**Model  
Error Resolution Document**

1. Document Number:	MDL-NBS-HS-000020	2. Revision/Addendum:	REV02 AD 02	3. ERD:	ERD 04
4. Title:	Particle Tracking Model and Abstraction of Transport Processes				
5. No. of Pages Attached:	57

**6. Description of and Justification for Change (Identify affected pages, applicable CRs and TBVs):**  
 This ERD is prepared to evaluate the impact of changes to the thorium sorption coefficient distributions (which were recommended for the impact analysis in order to resolve CR11020 (MDL-NBS-HS-000008 REV02 AD01 ERD02, in preparation)) on the UZ transport calculations (*Particle Tracking Model and Abstraction of Transport Processes*, MDL-NBS-HS-000020 REV02 AD 02 [DIRS 184748]) that supported the TSPA-LA, and on the TSPA LA model.

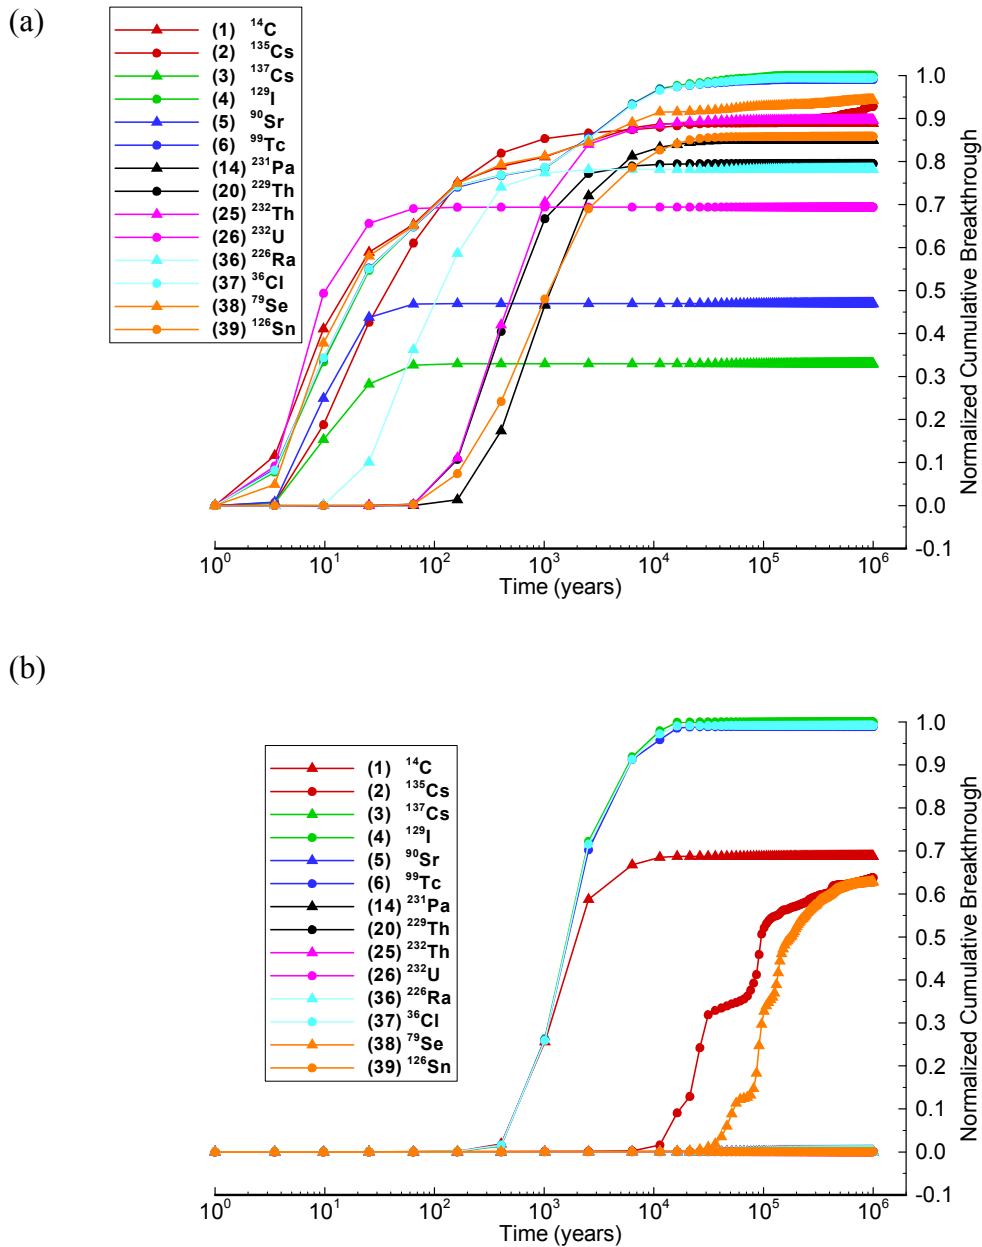
Figure 6.6.2-5[d] shows the normalized cumulative breakthrough curves for all species modeled as simple decay radionuclides ( $^{14}\text{C}$ ,  $^{135}\text{Cs}$ ,  $^{137}\text{Cs}$ ,  $^{129}\text{I}$ ,  $^{90}\text{Sr}$ ,  $^{99}\text{Tc}$ ,  $^{231}\text{Pa}$ ,  $^{229}\text{Th}$ ,  $^{232}\text{Th}$ ,  $^{232}\text{U}$ ,  $^{226}\text{Ra}$ ,  $^{36}\text{Cl}$ ,  $^{79}\text{Se}$ , and  $^{126}\text{Sn}$ ), corresponding to Figure 6.6.2-5[b] in MDL-NBS-HS-000020 REV 02 AD 02 [DIRS 184748] and Figure 2.3.8-43 in the Safety Analysis Report (SAR). The upper figure presents breakthrough curves for the northern release location, while the lower figure shows the breakthrough curves for the southern release location.

The results using the recommended Th  $K_d$  distributions are different from the corresponding results in MDL-NBS-HS-000020 REV 02 AD 02 [DIRS 184748] (Figure 6.6.2-5[b]) in that Th breaks through approximately 500 years earlier (50% breakthrough) for the northern release with the  $K_d$  changes. The southern release results remain essentially the same with very low normalized Th breakthrough of less than 0.001. Despite the difference shown here, the conclusion reached in MDL-NBS-HS-000020 REV 02 AD 02 [DIRS 184748] still remains the same.

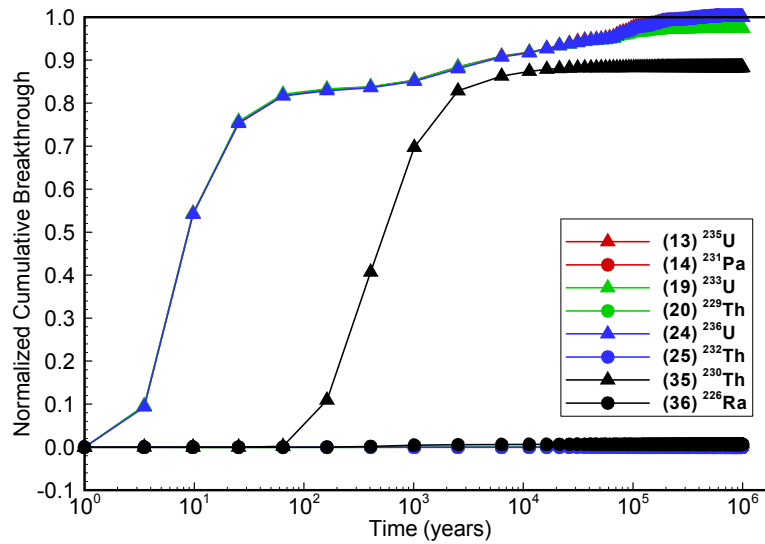
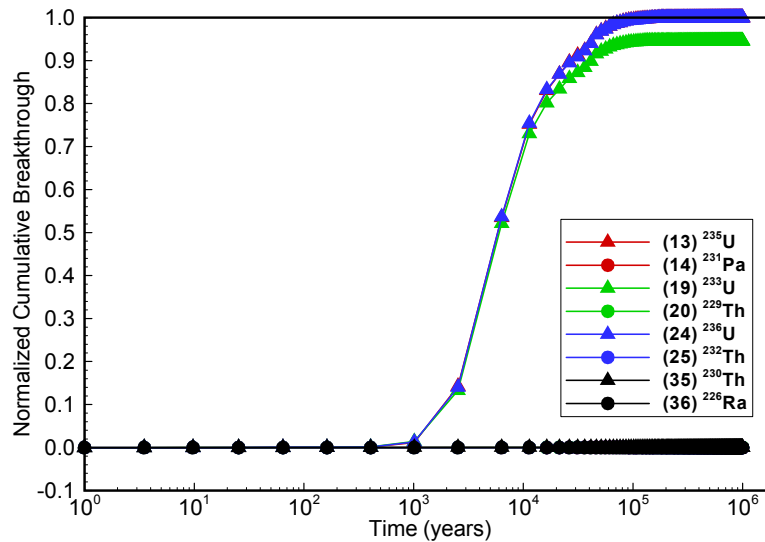
Figure 6.6.2-7[d], which corresponds to Figure 6.6.2-7[b] in MDL-NBS-HS-000020 REV 02 AD 02 [DIRS 184748], presents normalized breakthrough curves for radionuclide  $^{235}\text{U}$ ,  $^{233}\text{U}$ ,  $^{236}\text{U}$ , and  $^{230}\text{Th}$  and their daughter products  $^{231}\text{Pa}$ ,  $^{229}\text{Th}$ ,  $^{232}\text{Th}$ , and  $^{226}\text{Ra}$ , respectively for the two

release locations. These results using the Th  $K_d$  distributions as recommended for this analysis are essentially the same as in MDL-NBS-HS-000020 REV 02 AD 02 [DIRS 184748].

Figure A-1: CDF of Uncertainty in Thorium Sorption Coefficient in the Unsaturated Zone: Original vs. Alternate (DTN: LA0809SL831341.001)

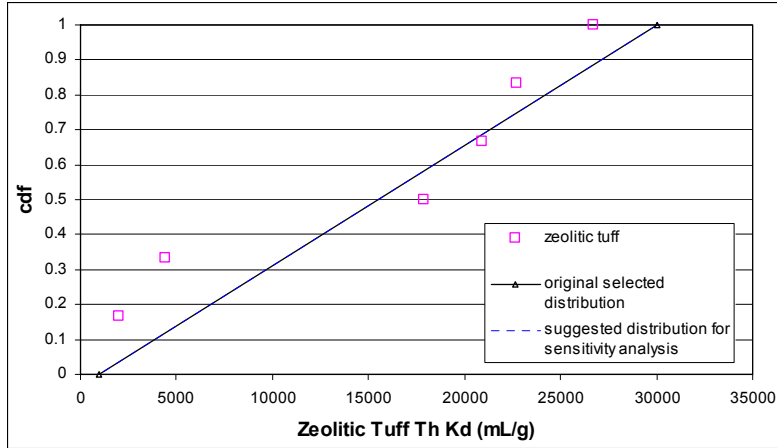
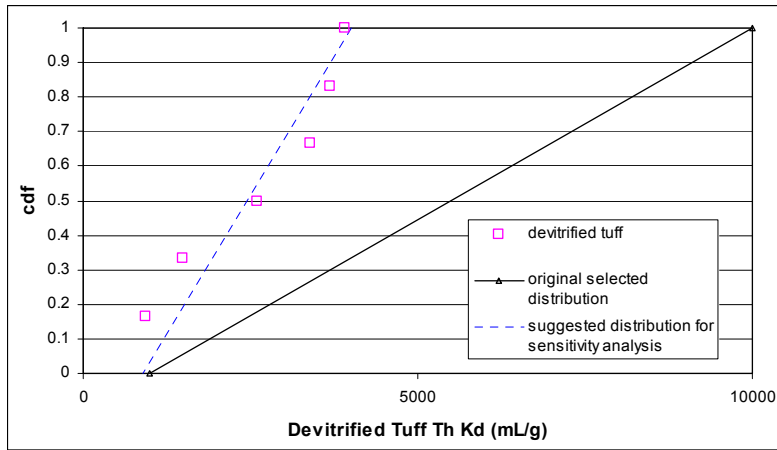
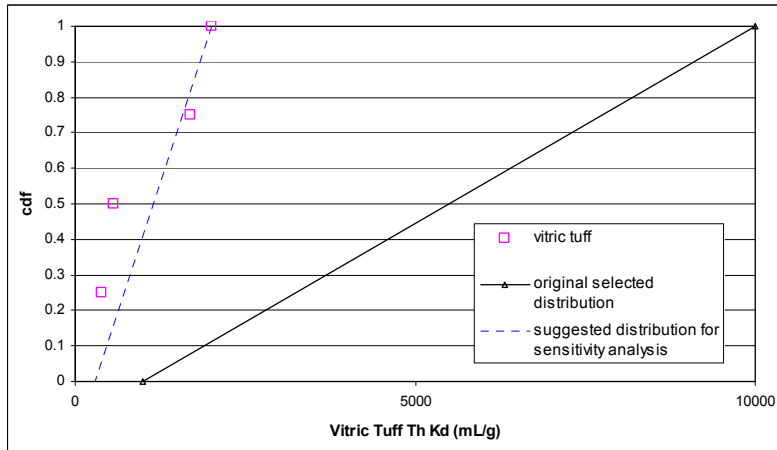
An alternate set of distributions used for sampling thorium sorption coefficients ( $K_{ds}$ ) in the unsaturated zone has been developed that may better reflect measured data to support the TSPA impact analysis. Figure A-1 shows the  $K_d$  distributions of zeolitic, devitrified and vitric tuff (original and alternate) together with measured data (DTN: LA0809SL831341.001). The figure shows that while the original zeolitic tuff  $K_d$  distribution reasonably reflects the measured data, the distributions for devitrified and vitric tuff needed to be modified. Tables A-1 and A-2 show the original and alternate  $K_d$  distributions for the unsaturated zone tuff units, respectively. Table A-3 shows the mean and standard deviation values of the original and alternate  $K_{ds}$ .

Figure A-2. Comparison of the Mean Annual Dose for the TSPA-LA Model to the Thorium  $K_d$  Changed Model for the IG One-Million-Year Modeling Case. Note: the base case is red line and the sensitivity case is black dashed line.

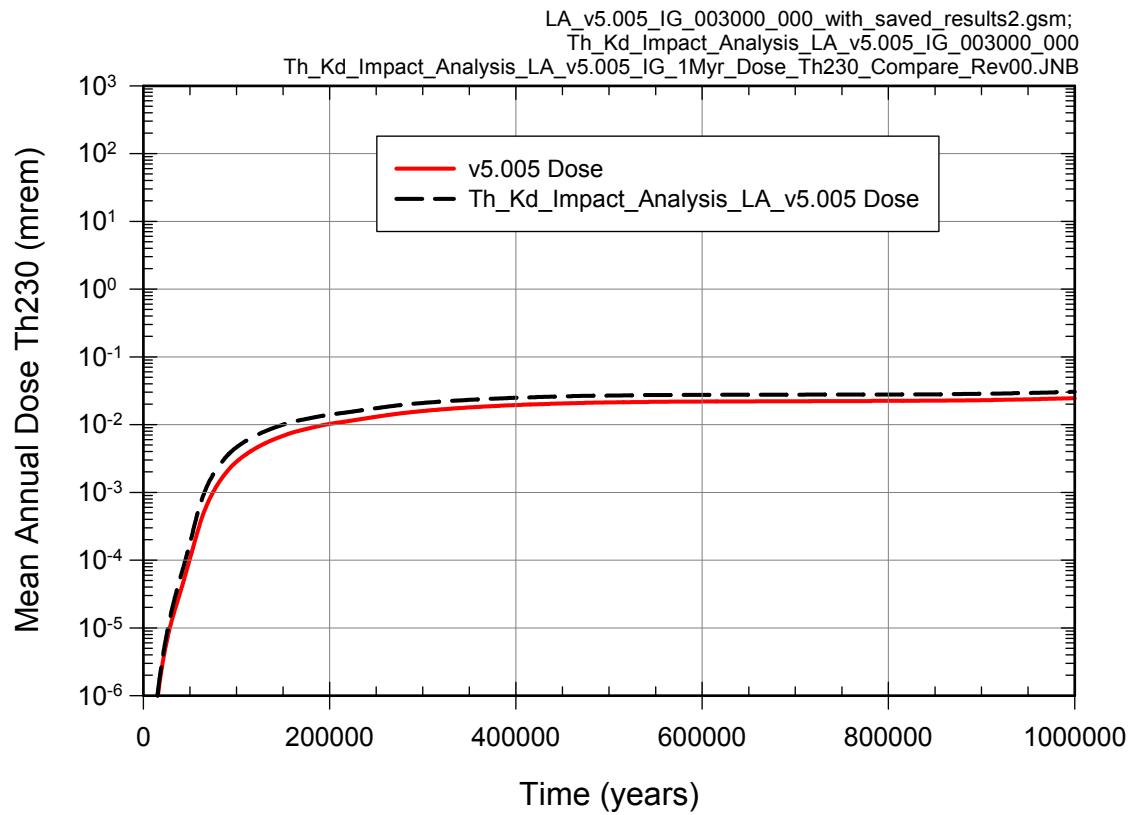
The results from the IG one-million-year Modeling Case are presented in Figure A-2. As can be seen in the Figure A-2, there is small difference between the mean annual dose results from the TSPA-LA simulations and those considering the new thorium  $K_d$  distributions. For the IG Modeling Case for one million years, the change in thorium  $K_d$  distributions increased the mean annual dose by 10% at the end of the simulation. The mean annual dose results from the SM one-million-year Modeling Case are presented in Figure A-11 and also show little change. For the SM one-million-year Modeling Case, the change in thorium  $K_d$  distributions increased the mean annual dose by only 3.7% at the end of the simulation. Because these two modeling cases dominate the total dose results for one million years, it can be surmised that any conclusions presented in SNL 2008 ([DIRS 183478], Section 8.1.1.2[a]) based on total dose will not change.

Figures A-2 to A-10 show the impact of the thorium  $K_d$  changes on the results of the IG one-million-year modeling case. Figure A-2 shows the thorium  $K_d$  changes have a small impact on the mean annual dose. The increase in mean annual dose for the IG one-million-year modeling case, at one million years, is about 10% (from 0.8861 mrem to 0.9786 mrem). The increases in the  $^{230}\text{Th}$  dose contribution (Figure A-3) and  $^{226}\text{Ra}$  dose contribution (Figure A-4) at one million years are about 24% (from 0.0244 mrem to 0.0302 mrem) and 27% (from 0.2306 mrem to 0.2922 mrem), respectively. The increases in the  $^{230}\text{Th}$  dose contribution (Figure A-3) and  $^{226}\text{Ra}$  dose contribution (Figure A-4) basically reflect the increase in release of  $^{230}\text{Th}$  from the EBS, as depicted in Figure A-5. How the change in thorium  $K_d$  distributions impacts the transport processes can be seen by examining the releases of  $^{230}\text{Th}$  and  $^{226}\text{Ra}$  from the EBS, UZ, and SZ. The increase in release of  $^{230}\text{Th}$  from the EBS is about 25% (from 0.0530 g/yr to 0.0660 g/yr) at one million years. As can be seen in Figure A-6, this increase is associated with a slight decrease in  $^{226}\text{Ra}$  release from the EBS, which decreases about 7% (from 0.0213 g/yr to 0.0198 g/yr) by one million years. The decrease in  $^{226}\text{Ra}$  release is associated with the decrease in  $^{230}\text{Th}$  within the EBS (due to the increase in release) and associated decrease in the formation of daughter product. As can be seen in Figures A-7 and A-8, the release of  $^{230}\text{Th}$  from the UZ reflects the increase of  $^{230}\text{Th}$  released from the EBS, and the release of  $^{226}\text{Ra}$  from the UZ reflects the

Figure A-9. Comparison of Mean SZ <sup>230</sup>Th Release for the TSPA-LA Model to the Thorium  $K_d$  Changed Model for the IG One-Million-Year Modeling Case. Note: the base case is red line and the sensitivity case is black dashed line.

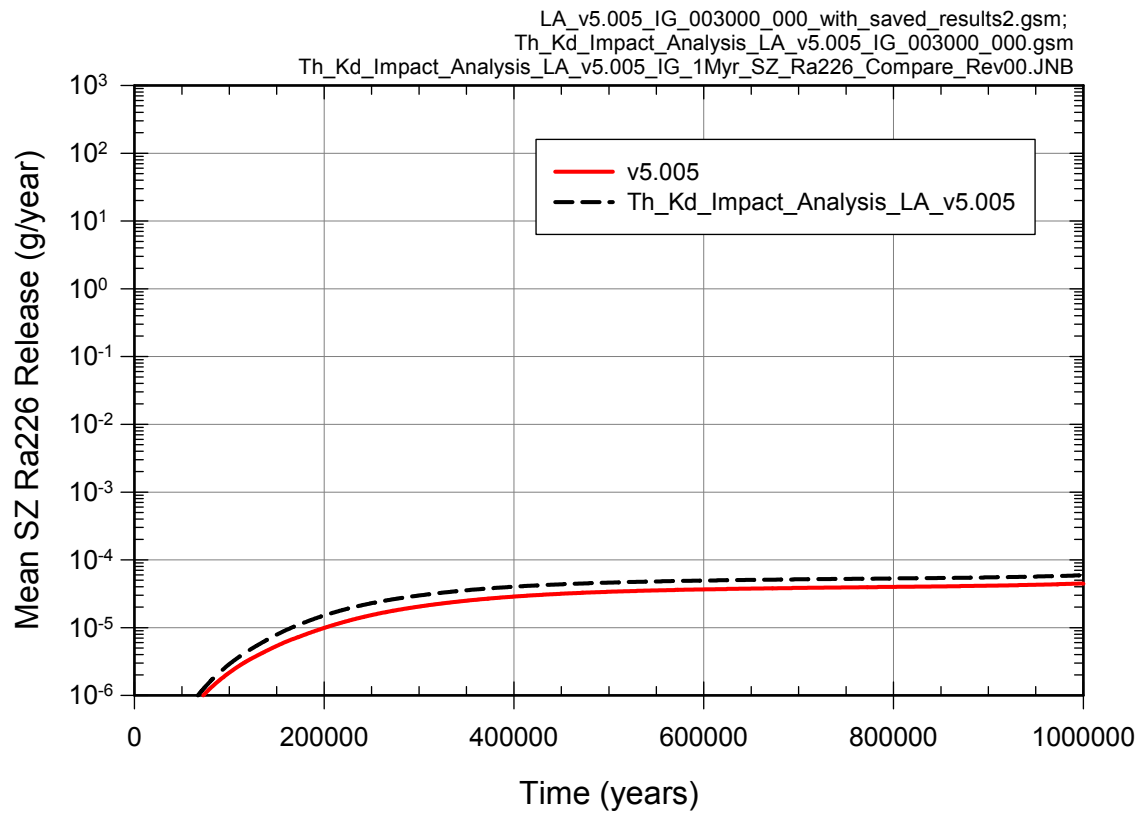
decrease of  $^{226}\text{Ra}$  released from the EBS. Examining the  $^{230}\text{Th}$  releases from the SZ presented in Figure A-9 shows that, as expected, the release of  $^{230}\text{Th}$  from the SZ reflects the increase of  $^{230}\text{Th}$  released from the EBS and UZ. Examining the releases of  $^{226}\text{Ra}$  from the SZ presented in Figure A-10 shows that the release of  $^{226}\text{Ra}$  from the SZ is also a function of the increase of  $^{230}\text{Th}$  released from the EBS and UZ, as  $^{230}\text{Th}$  decays to  $^{226}\text{Ra}$  during transport through the SZ.

Figure A-11. Comparison of Mean Annual Dose for the TSPA-LA Model to the Thorium  $K_d$  Changed Model for the SM One-Million-Year Modeling Case. Note: the base case is red line and the sensitivity case is black dashed line.

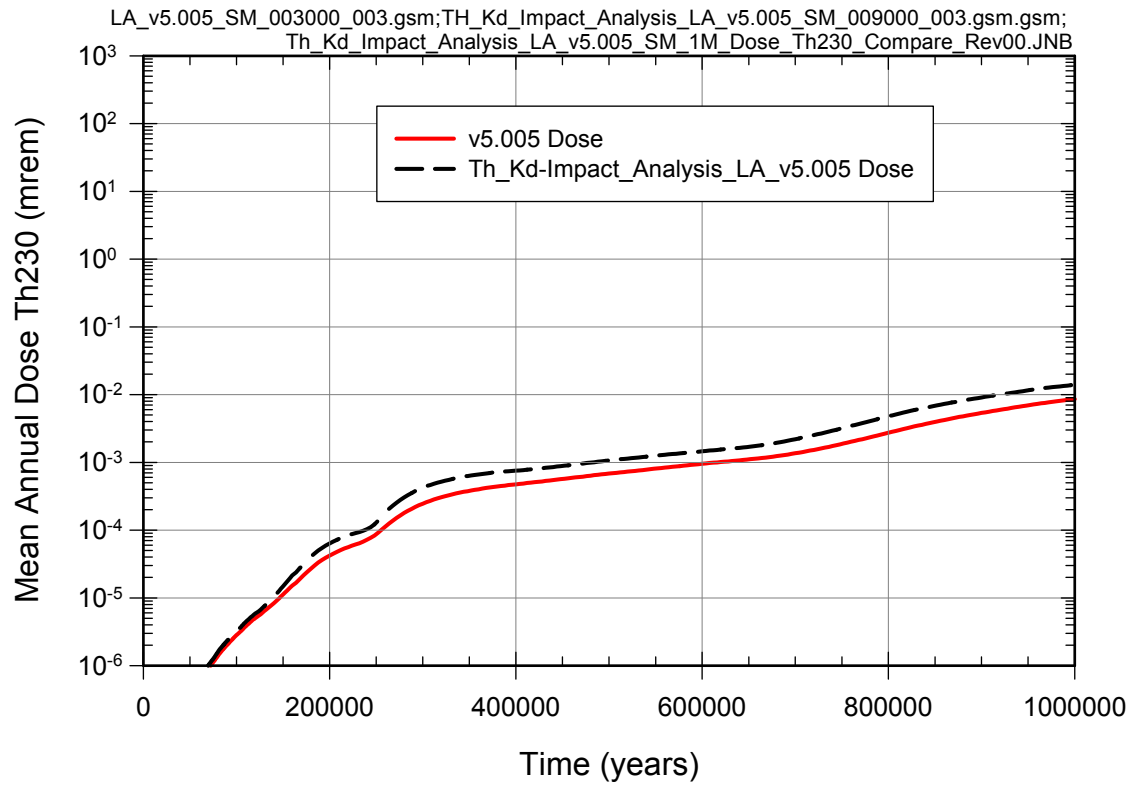
Figures A-11 to A-13 show plots of mean annual dose,  $^{230}\text{Th}$  dose contribution, and  $^{226}\text{Ra}$  dose contribution for the SM one-million-year modeling case. As shown in Figure A-11, the thorium  $K_d$  changes have a very small impact on the mean annual dose. There is an increase in the mean annual dose of approximately 3.7% (from 1.0960 mrem to 1.1365 mrem) at one million years. Note that this small increase reflects the relative unimportance of the thorium and radium radionuclides in the one-million-year SM Modeling Case compared to  $^{99}\text{Tc}$ ,  $^{129}\text{I}$ , and  $^{242}\text{Pu}$ , as shown in Figure 8.2-12[a] of SNL 2008 [DIRS 183478]. There are substantial changes to the dose contributions from  $^{230}\text{Th}$  and  $^{226}\text{Ra}$  associated with the changes in thorium  $K_d$ s, as shown in Figures A-12 and A-13, respectively. At one million years, there is an increase in the dose contribution from  $^{230}\text{Th}$  of 61% (from 0.00859 mrem to 0.0138 mrem) and an increase in the dose contribution from  $^{226}\text{Ra}$  of 37% (from 0.0441 mrem to 0.0603 mrem).

Figure A-14. Comparison of Mean Annual Dose for the TSPA-LA Model to the Thorium  $K_d$  Changed Model for the HI One-Million-Year Modeling Case. Note: the base case is red line and the sensitivity case is black dashed line.

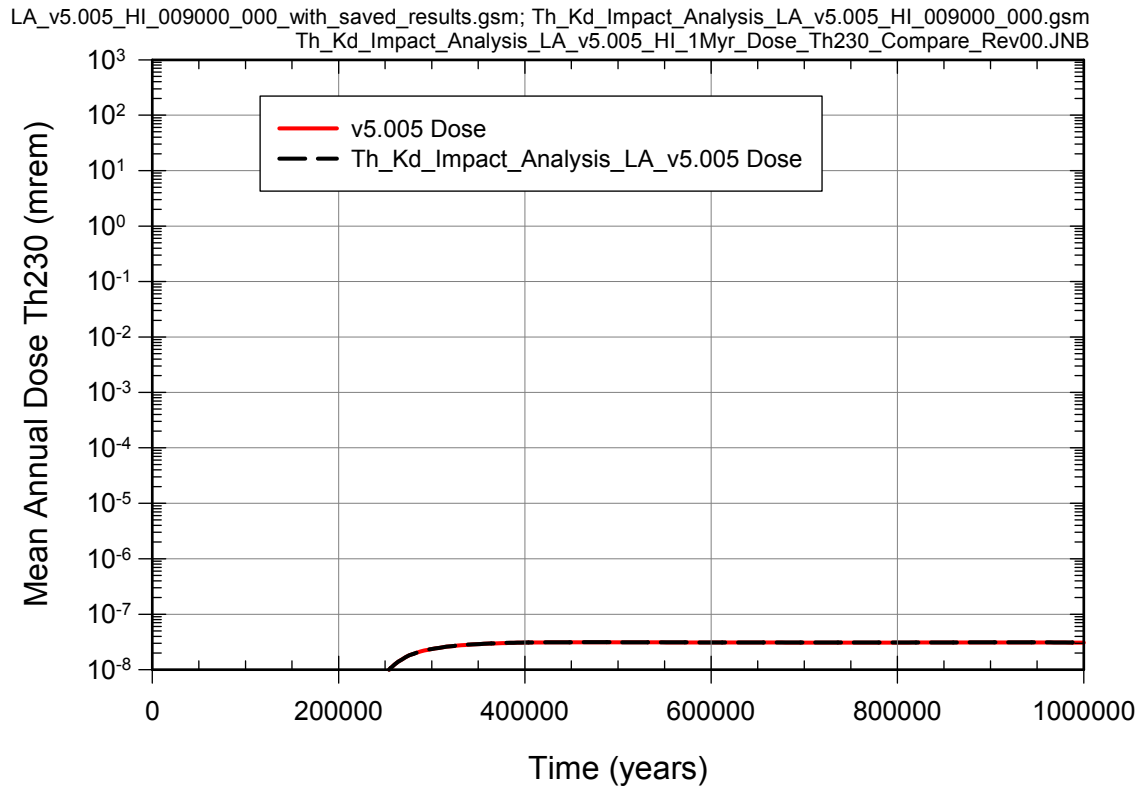
A similar comparison of the mean annual dose results for the HI Modeling Case is presented in Figure A-14. Little difference can be seen between the TSPA-LA modeling results and those considering the new thorium  $K_d$  distribution. Thus conclusions based on the HI results presented in the TSPA-LA AMR (SNL 2008 [DIRS 183478], Section 8.1.3.2[a]) would be unaffected by the changes in the thorium  $K_d$  distributions for devitrified and vitrified tuffs.

Figures A-14 to A-16 show the impact of the thorium  $K_d$  changes on the mean annual dose from HI, and the contributions to mean annual dose from  $^{230}\text{Th}$  and  $^{226}\text{Ra}$ . As shown in the plots, there is very little change in results due to the thorium  $K_d$  changes. Note that since the HI one-million-year model bypasses the invert and EBS/UZ interface (SNL 2008 [DIRS 183478], Section 6.7), the EBS releases would not be affected by the  $K_d$  change. The only influence on the EBS release would be in the diffusion from the borehole to the surrounding rock matrix. As discussed in SNL 2008 [DIRS 183478], Section 7.7.1.6[a] the diffusion from the borehole into the surrounding rock matrix dominates the borehole transport process for aqueous species with higher  $K_d$ s such as plutonium. In the case of  $^{230}\text{Th}$ , which has a  $K_d$  range that is much higher than that of plutonium, only a negligible amount of  $^{230}\text{Th}$  will exit from the borehole. This means that  $^{230}\text{Th}$  released from the SZ is mainly the daughter product of  $^{234}\text{U}$  transported through the SZ. For this reason, changing the thorium  $K_d$  distributions has a negligible impact on the mean dose contributions from  $^{230}\text{Th}$ . Similarly, the  $^{226}\text{Ra}$  release from the SZ is dominated by  $^{230}\text{Th}$  decaying to  $^{226}\text{Ra}$  in the SZ. Therefore, there is little change in the mean dose contributions from  $^{226}\text{Ra}$  associated with changing the thorium  $K_d$  distributions.

Figure A-17. Comparison of Mean Annual Dose for the TSPA-LA Model to the Thorium  $K_d$  Changed Model for the ED 10, 000-Year Modeling Case. Note: the base case is red line and the sensitivity case is black dashed line.

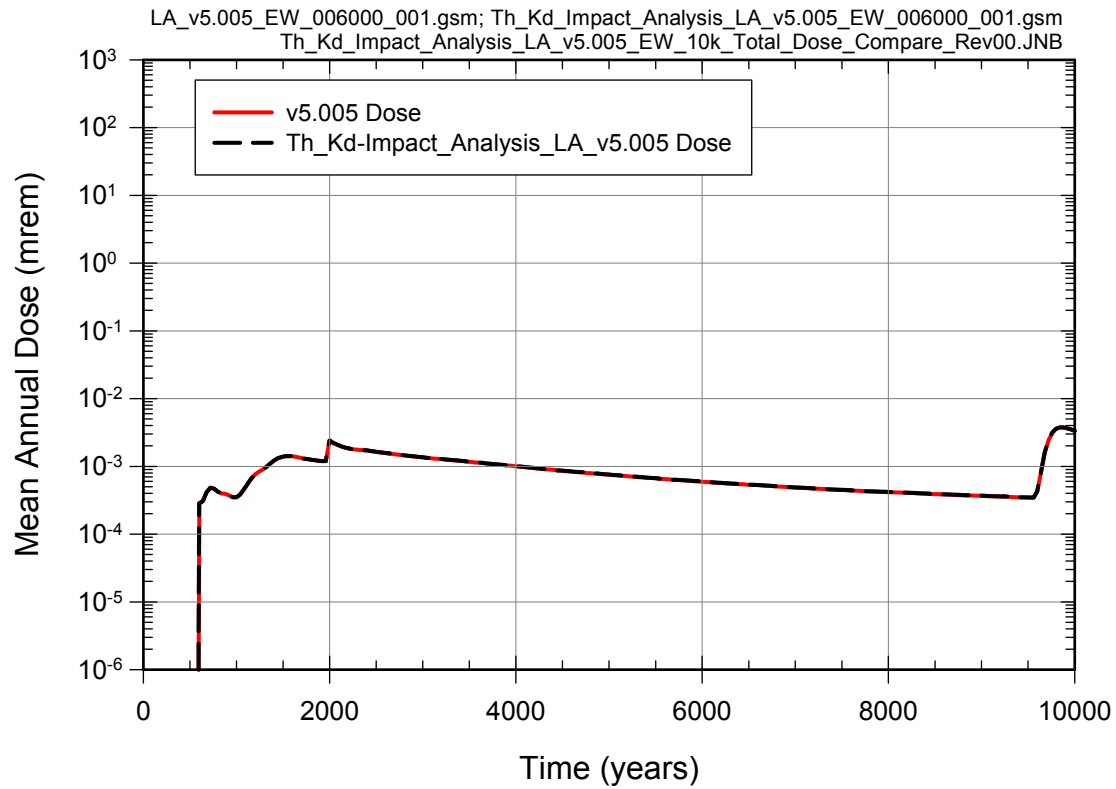
Figure A-17 shows plots of mean annual dose for the ED 10,000-year modeling case. The thorium  $K_d$  changes have little impact on mean annual dose. As discussed above in Section A.3, for 10,000-year modeling cases,  $^{230}\text{Th}$ ,  $^{232}\text{Th}$ ,  $^{226}\text{Ra}$ , and  $^{228}\text{Ra}$  are not considered in dose calculations. The negligible dose changes depicted in Figure A-17 reflect changes in the dose contribution from  $^{229}\text{Th}$ , which is a small contributor to dose as shown in SNL 2008 [DIRS 183478], Figure 8.2-4[a].
